E8363B-03

S E R V I C E N O T E

E8363B PNA Microwave Network Analyzers

Figure 1: A3 Front Panel Interface Board Assy without the Bracket

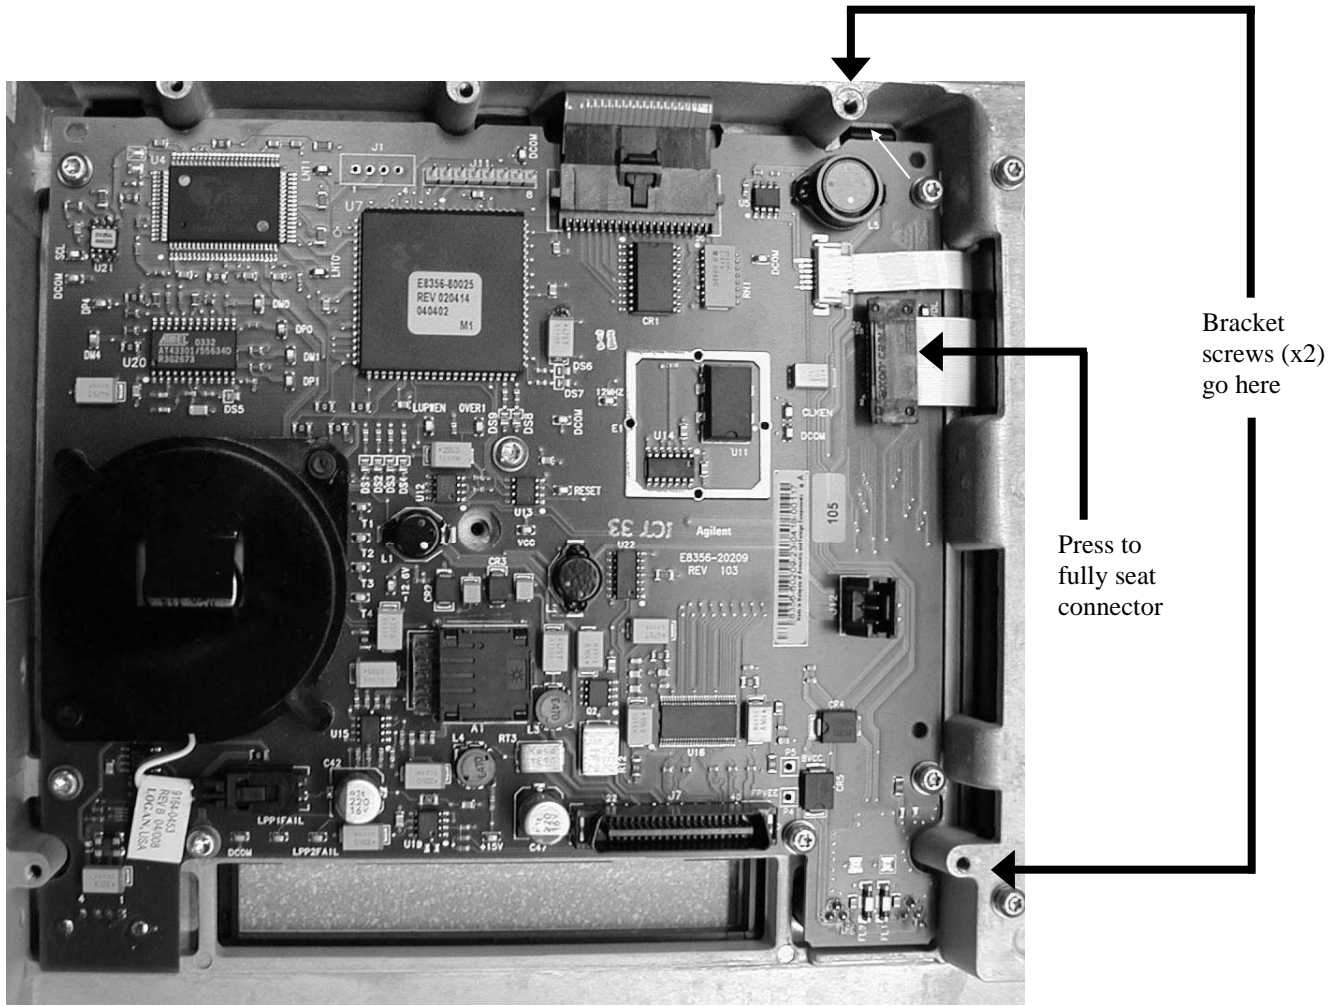
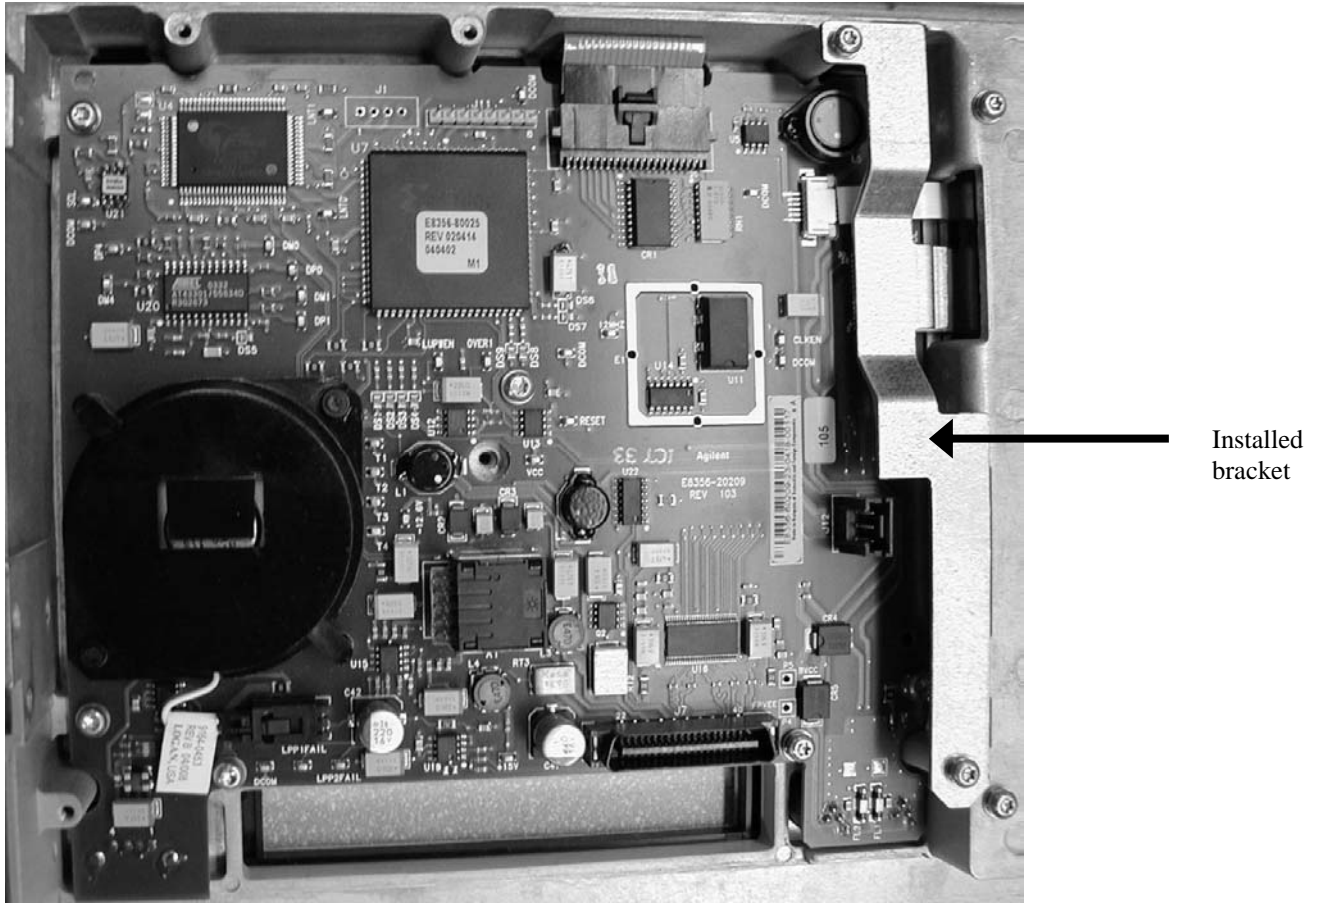
A connector of the ribbon cable (Agilent part number 8120-8409) that joins the front panel display to the front panel interface board can loosen, causing a display failure, unless a new bracket is installed. Because the failure rate has been very low, it is recommended that the bracket be installed only when there is an additional reason to remove the PNA front panel.

1. Refer to Figure 1 in this document:
 - Press down firmly on the ribbon cable's black connector.
 - Locate the two tapped holes for the bracket screws.
2. As shown in Figure 2 in this document, position the bracket so that its holes line-up with the two holes you located in the previous step.
3. Hand-start the two screws, and then torque both to 9 in-lbs.
4. Reinstall the PNA Front Panel by following the Service Guide instructions in the "Replacement Procedure." This is located on the same page as the "Removal Procedure" used previously in step 7.
